STAFF REPORT
COMMUNITY DEVELOPMENT DEPARTMENT

HEARING DATE: 3/17/2022
 TO: Planning & Zoning Commission
 FROM: Alan Tiefenbach, Associate Planner
 208-884-5533
 SUBJECT: H-2021-0102
 Pavilion at Windsong
 LOCATION: 1680 W. Ustick Rd.

E. Concept Plan – Remarked (date: 12/20/2021)

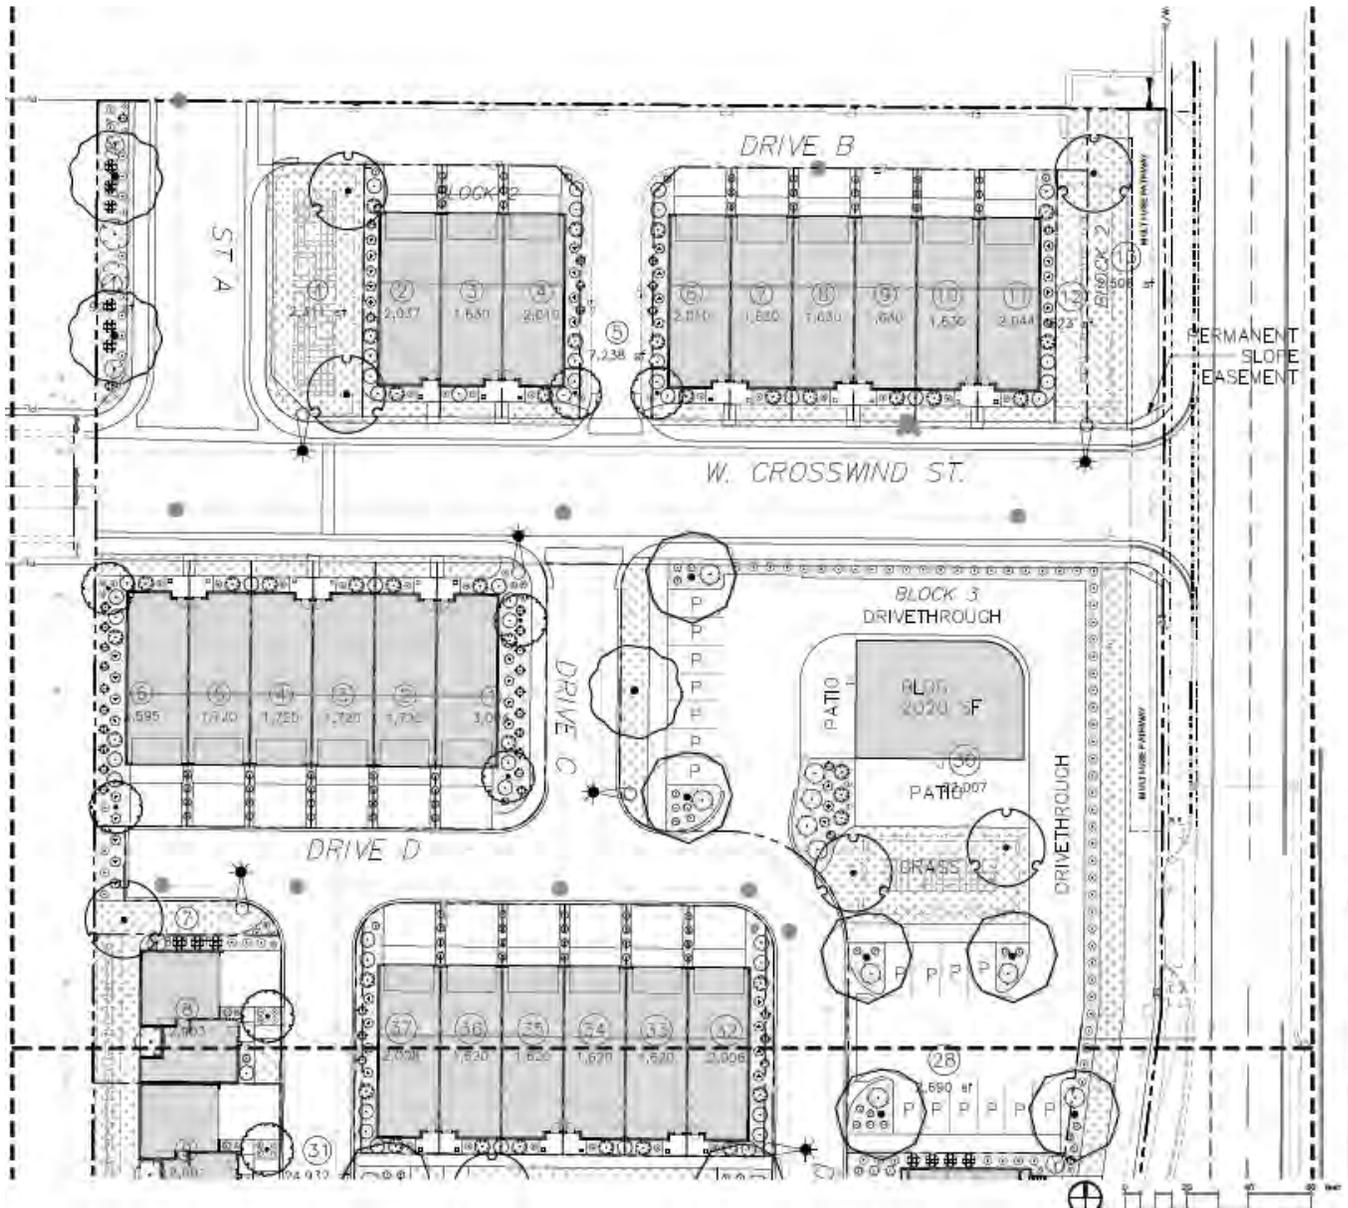
The concept plans show a townhouse row indicated as “Building D” along the western property line as close as 30 feet from existing residences. Staff does have concerns with the impact of a “wall effect” of these townhomes on the Windsong No 2 Subdivision. **As a condition of approval, staff recommends Building D be broken into at least two groups of buildings, with the break occurring approximately in the vicinity of Lot 19, Block 3 of the Windsong Subdivision No 2.**

On the north side of W. Crosswind St., the plat indicates a private alley (east-west) and N. Puff Ln (north-south). Neither of these roadways meet minimum requirements. Alleys need to connect on both ends to serve as fire lanes, whereas the alley that is shown north of Buildings A & B dead-ends to the east. Also, N. Puff Ln is shown to be 23 ft. in width whereas 24' ft is the minimum. The applicant should revise this portion of the plat to meet the requirements of UDC 11-6C. This could be done by widening the alley and N. Puff Ln to at least 24 ft. in width, or converting the "alley" to a common drive and removing units to comply with the maximum allowed number of units allowed per UDC 11-6C-3-D (4 total, with no more than 3 on one side).

Staff supports providing multiuse pathways but finds the configuration as proposed redundant and unnecessary. At the east along N. Linder Rd., the plans propose a 10 ft. wide pathway directly adjacent to the existing 7 ft. wide sidewalk. Similarly, the applicant proposes to provide a 10 ft. wide pathway slightly offset from the existing sidewalk on W. Ustick Rd. **In order to reduce impervious surfacing, unnecessary construction and increase landscaping, staff believes it is unnecessary to provide the additional pathway along N. Linder Rd and that the existing 7 ft. wide attached sidewalk should remain. The sidewalk along W. Ustick Rd should be widened to 10 ft. wide, the pathway shown directly south of Building H should be eliminated, and the connection between the existing Five Mile Creek Pathway and the W. Ustick Road Pathway should be shifted further to the west (this has been red-marked on the concept plan shown in Exhibit IX). Also, staff has concerns with the multiple walkways connecting Buildings G and H to the pathways. For less conflict points, staff recommends the plans be revised to include only one walkway connection to the pathways from each building.**

The concept plan as submitted indicates an alley or private drive directly abutting the residentially-zoned parcel to the north. To provide buffering and a softer transition, staff recommends a 5 ft. wide landscape buffer in this area, landscaped as required by UDC 11-3B-8.

- f. Building D along the western property line shall be broken into at least two groups of buildings, with the break occurring approximately in the vicinity of Lot 19, Block 3 of the Windsong Subdivision No 2.

- d. Parking spaces shall be subtracted out of all areas indicated as useable open space.
7. The landscape shall be revised as follows:
 - a. The additional pathway along the south perimeter shall be removed, and the sidewalk along W. Ustick Rd shall be widened to a 10 ft. wide pathway along the property line, with a 10 ft. wide connection to the Five Mile Creek Pathway at the west perimeter of the site.

- b. The pathway shown along N. Linder Rd shall be revised to include only the existing 7 ft. wide sidewalk.
 - c. There shall be no more than one walkway per building connecting to the pathways and sidewalks along W. Ustick Rd. and N. Linder Rd.

- d. A landscape buffer of at least 5 ft. in width, meeting the planting requirements of UDC 11-3B-9, shall be required along the northern property line or as otherwise required by UDC 11-3B.
